**Re: Pima County Comments – Rosemont Copper Mine Preliminary Administrative Final Environmental Impact Statement**

Attached please find comments regarding the Rosemont Copper Mine Preliminary Administrative Final Environmental Impact Statement (PAFEIS) from Pima County and the Pima County Regional Flood Control District, collectively referred to as Pima County in this letter.

FIGURE 1. Post-closure Stormwater Issues – Appendix B: FS-SW-02

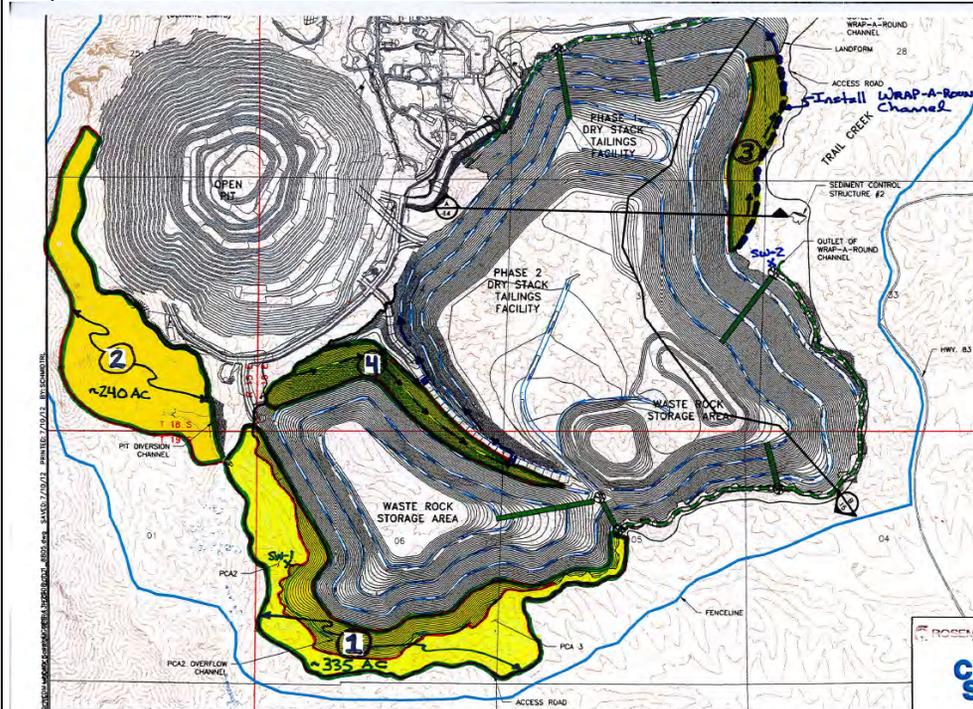
2. Release Additional Surface Water from the Lower Tailings Mound Sideslope  
 An additional wraparound or perimeter channel should be constructed along the northeastern side of the Tailings mound. As shown on Figure 1, there is no collection channel planned to transfer water collected at the bottom of the Area 3 sideslope interval. Instead, stormwater collected on this lower sideslope ponds along the base of the sideslope within three primary headwater areas below the adjacent north-trending ridgeline. This situation is similar in nature to the trapped water in the PCAs noted in Part 1 above.

As indicated on Figure 1, a perimeter channel should be designed and constructed to collect and transfer stormwater from the base of the subject sideslope, by utilizing the same techniques noted above in Part 1 (operations A, B and C). Collected stormwater should be routed into the lowest planned bench at the northeast corner of the Tailings mound, for transmission release into the wraparound channel and release in
